**ENCLOSURE 1**

**DESCRIPTION AND ASSESSMENT OF THE PROPOSED CHANGE**

Ameren Missouri (Union Electric Company) proposes to amend Operating License NPF-30 for Callaway Plant Unit 1 (Callaway). The proposed amendment would revise the Technical Specifications (TSs), the TS Bases, and the Final Safety Analysis Report (FSAR) to reflect the results of an updated criticality safety analysis (CSA) for the storage of spent fuel. The updated CSA (1) revises the current CSA based on the latest methodologies consistent with current NRC guidance and acceptance criteria, (2) simplifies the storage configuration by establishing two regions within the spent fuel racks (SFRs) located within the spent fuel pool (SFP), and (3) provides an evaluation that encompasses a future fuel design. The scope of this change does not include the new fuel storage facility.

**Figure 1 – Permissible Loading Configurations**

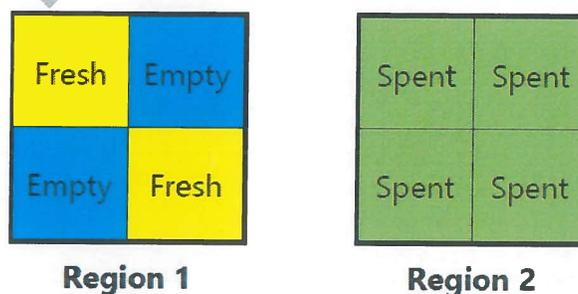
This proposed amendment simplifies the three-region MZTR model by changing it to a two-region model as described below and depicted in Figure 1.

- Region 1 – A 2x2 checkerboard pattern with two fresh fuel assemblies and two empty storage cells. For this application, the term "fresh fuel assembly" also includes assemblies not meeting the criteria for storage in Region 2.
- Region 2 – A uniform loading of spent fuel assemblies in all available loading cells. For this application, the term "spent fuel assembly" includes assemblies meeting the criteria for storage in Region 2.

Figure 2 –Example of Proposed TS Figure 3.7.17-1

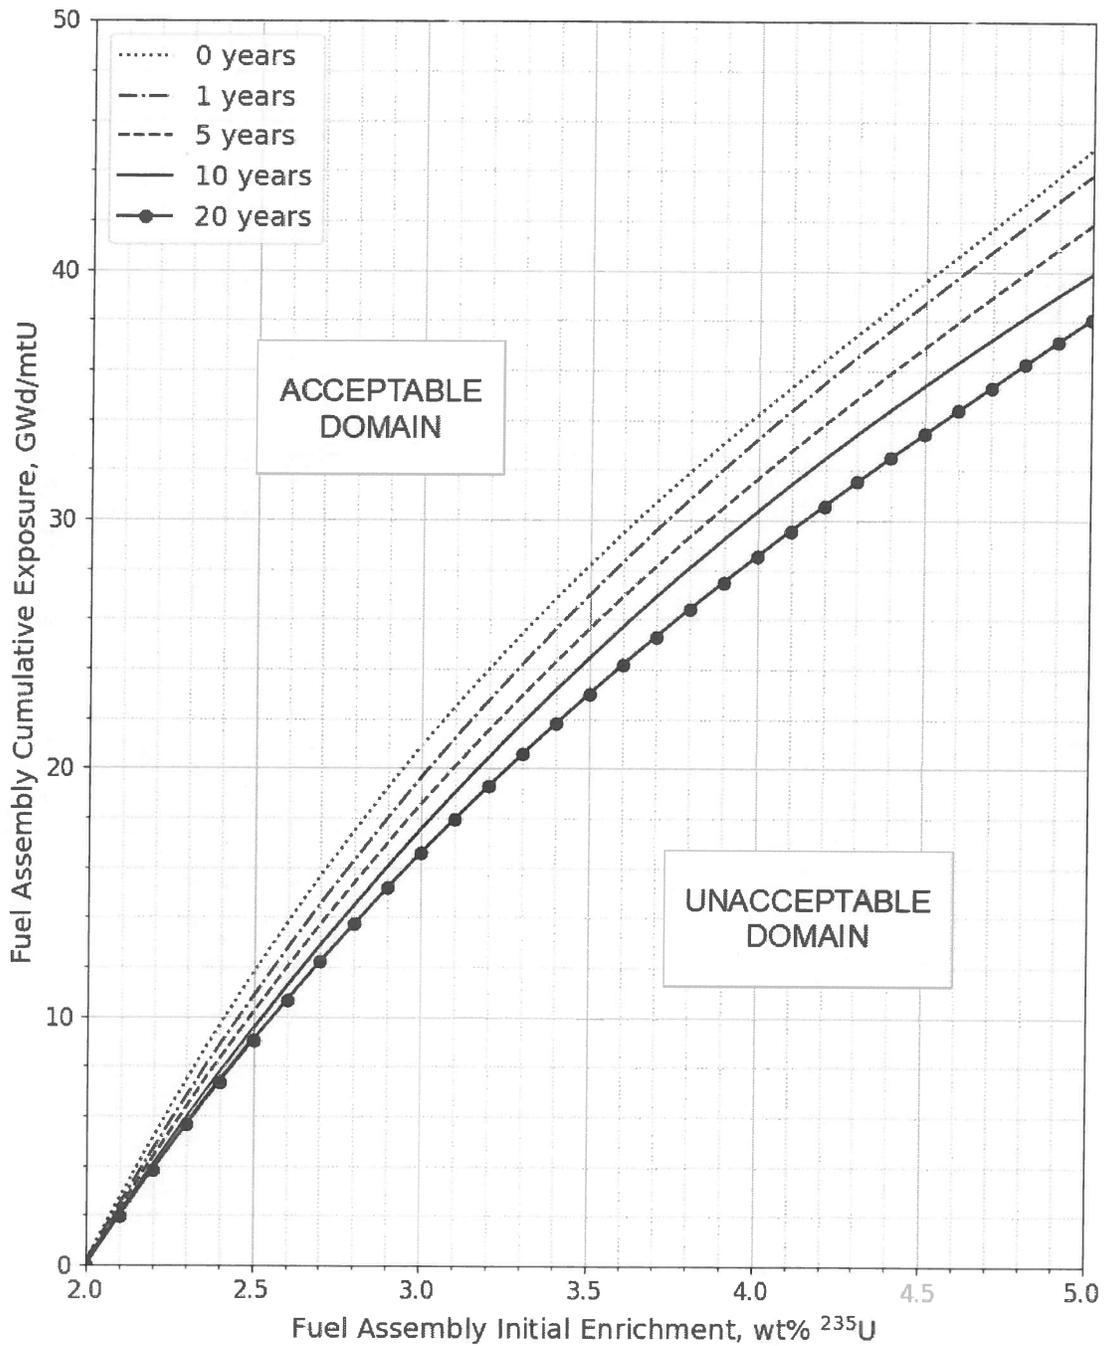
Current TS Figure 3.7.17-1, "Minimum Required Fuel Assembly Burnup as a Function of Initial Enrichment to Permit Storage in Regions 2 and 3," is revised as shown in Attachment 2. An illustrative figure is provided in Section 3.3.3, below, as Figure 2. Because Region 3 is being eliminated, the title of Figure 3.7.17-1 is revised to "Minimum Required Fuel Assembly Burnup as a Function of Initial Enrichment to Permit Storage in Region 2." The revised figure continues to define the spent fuel assembly storage location requirements as a function of Fuel Assembly Cumulative Exposure (in GWd/mtU) versus Fuel Assembly Initial Enrichment (in wt% U-235). The revised figure defines the required fuel assembly cumulative burnup as a function of initial enrichment and cooling time (i.e., decay time following removal from the core). There are five curves differentiating the Acceptable Domain from the Unacceptable Domain for storage in Region 2. The curves are based on analyses performed with fuel assembly cooling times ranging from zero years (i.e., freshly discharged fuel) to twenty years.

The existing three-region burnup curve, i.e., TS Figure 3.7.17-1, is being revised to define the criteria for the two-region storage configuration. The new TS figure continues to define the spent fuel assembly storage location requirements as a function of Fuel Assembly Cumulative Exposure (in GWd/mtU) versus Fuel Assembly Initial Enrichment (in wt% U-235). Additionally, the new figure specifies the acceptable domain for storage in Region 2 as a function of fuel assembly cooling time. There are five curves differentiating the Acceptable Domain from the Unacceptable Domain for storage in Region 2. The curves are based on analyses performed with fuel assembly cooling times ranging from zero years (freshly discharged fuel) to twenty years as described in sections 3.3.6.2 and 7.6.2 of Attachment 6. There are no changes proposed that pertain to the new fuel storage area. An example of new TS Figure 3.7.17-1 is shown in Figure 2.

The proposed burnup curves apply to all fuel currently in the SFP, as well as the anticipated future fuel design. As discussed in Section 5.1.2 of NEI 12-16, each of the legacy fuel types, along with the future GAIA fuel assemblies were evaluated.
